3 Taxonomy of WDM-PON-based Optical Access Network Technologies

Figure 1: Various options for a WDM-PON

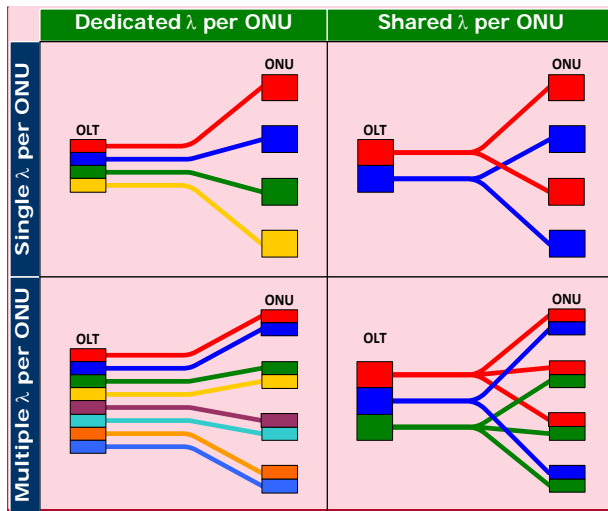
Commented [MH1]: Update the figure per comments from R07

Also, update the document to use terms C-OLT and C-ONU, as defined in SIEPON (copy definitions or reference them to SIEPON).

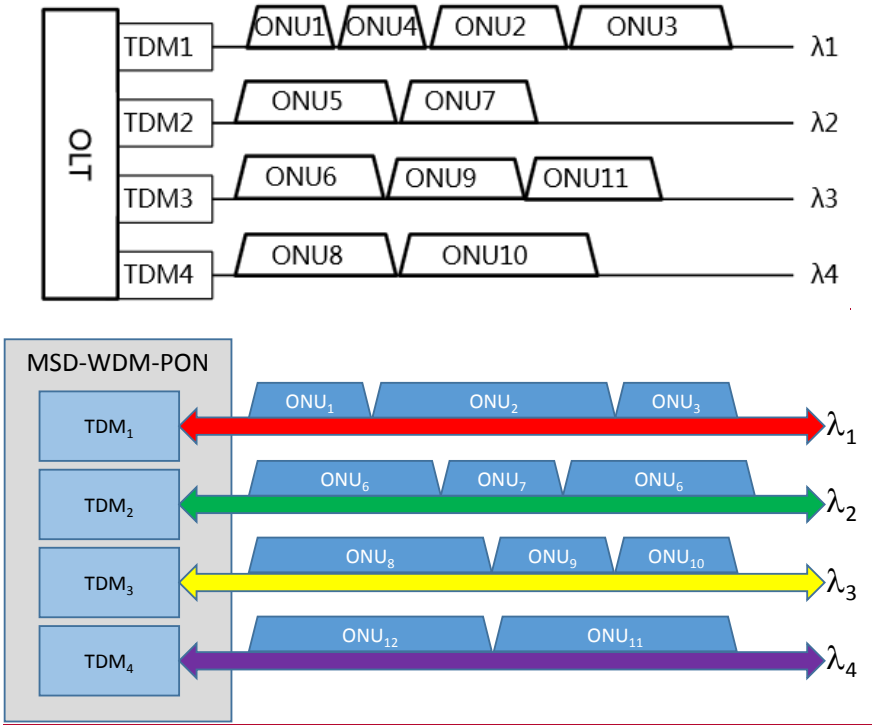
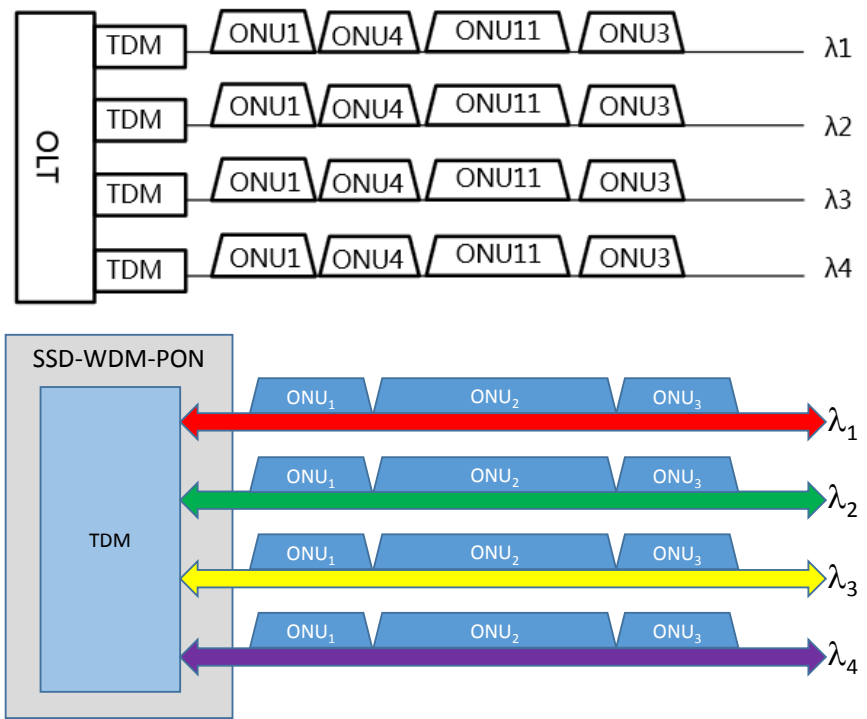
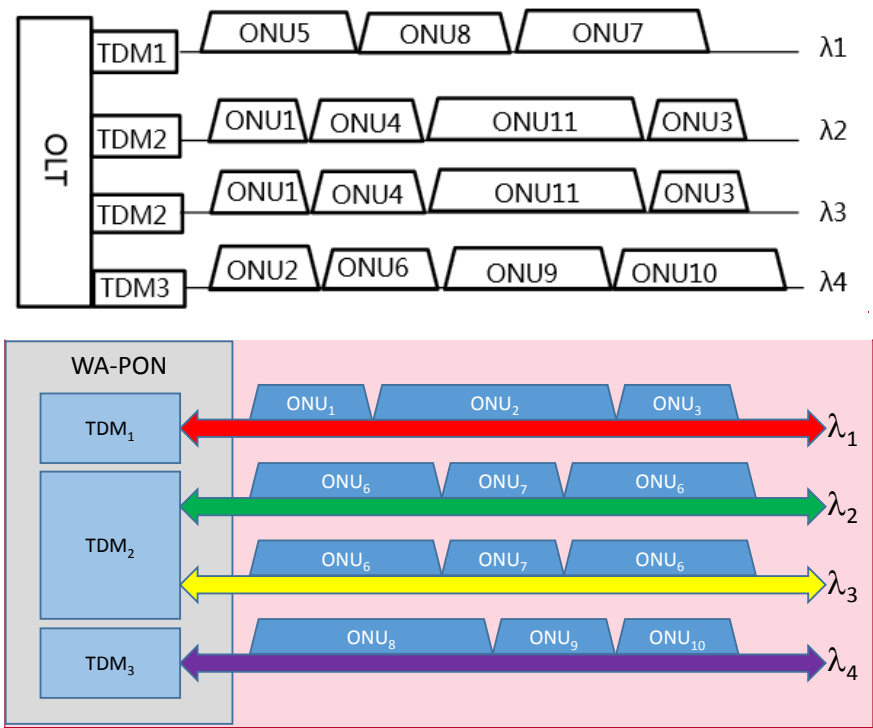
Commented [MH2]: Glen to provide new figures with "Scheduling Domain" and not "TDM".
